**STATE SIGNIFICANT DEVELOPMENT APPLICATION 61400212  
APPLICANT: THIRD.1 GROUP**

**North Sydney Council Response to RTS  
25 Hume St Crows Nest Site B OSD**

**Attachment 1 - SSD-61400212**

**SITE:** 25 Hume Street CROWS NEST 2065  
SSD-61400212 - Crows Nest OSD Site B Proposed over station mixed use and residential development comprising of: 122 Residential units and 78 above ground car spaces

Figure 1. Proposed Crows Nest TOD uplift (source: 3D model provided by DPHI)

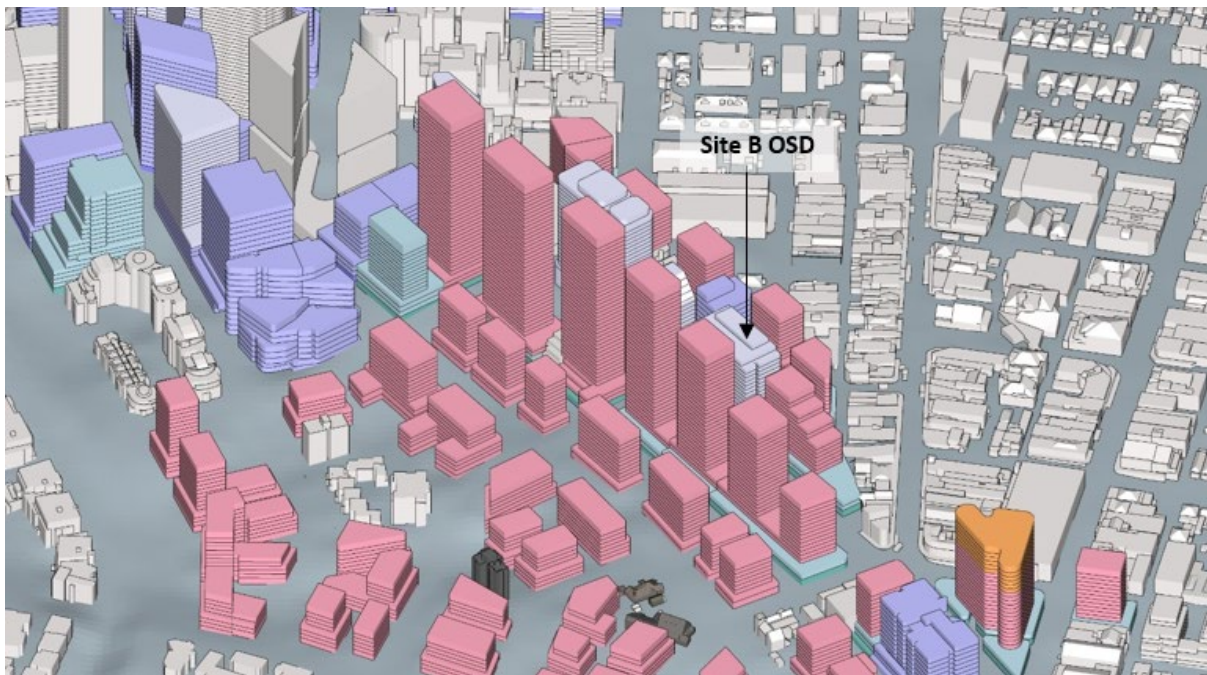
In November 2024, the Crows Nest TOD rezoning introduced significant increases in density beyond what was planned under the NSW Government’s previous “2036 Plan”. These changes fundamentally reshape the precinct’s context and set new expectations for future development. Accordingly, Site B needs to carefully respond to this changing environment, particularly with respect to the dense cluster of future residential towers on adjacent sites along Clarke Lane and Pacific Highway (Figure 1).

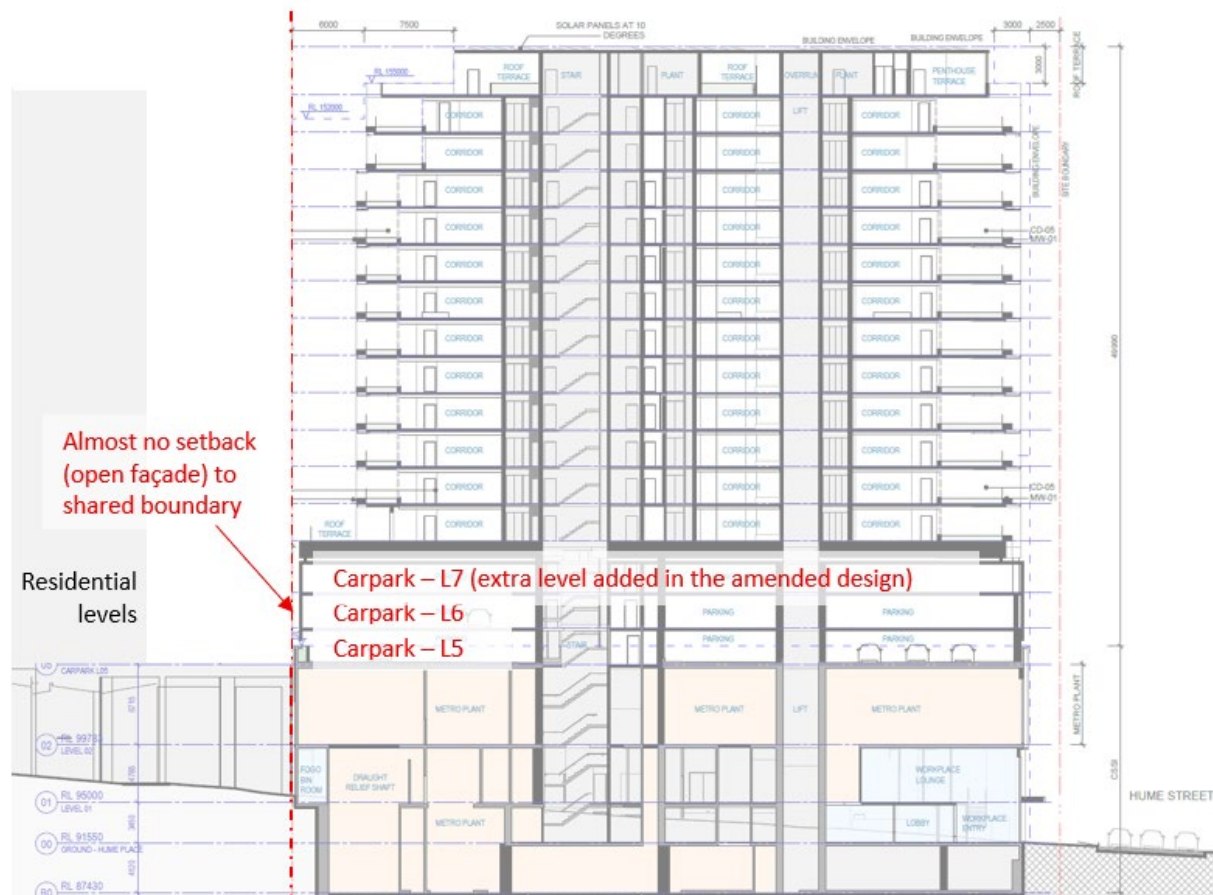
2.1 The tower envelope has not been amended, and the separation to the southern site and to the eastern site remains non-compliant with Apartment Design Guide (ADG) minimum requirements.

Setback - <b>Application</b>	Setback - <b>ADG</b>	<b>Compliance</b>
<b>South (along Pacific Hwy)</b>	5.4-6.3m	12m	No
<b>East (Clark Lane)</b>	6m (to centreline of Clark Lane)	12m	No

2.2 Previously, the applicant argued that smaller setbacks based on an 8-storey height limit for adjacent sites. However, the Crows Nest TOD rezoning has increased the allowable heights for the adjacent southern site to 16 storeys and the eastern site to 18 storeys, indicating a total recommended 24 m separation above 8 storeys (12 m each side).
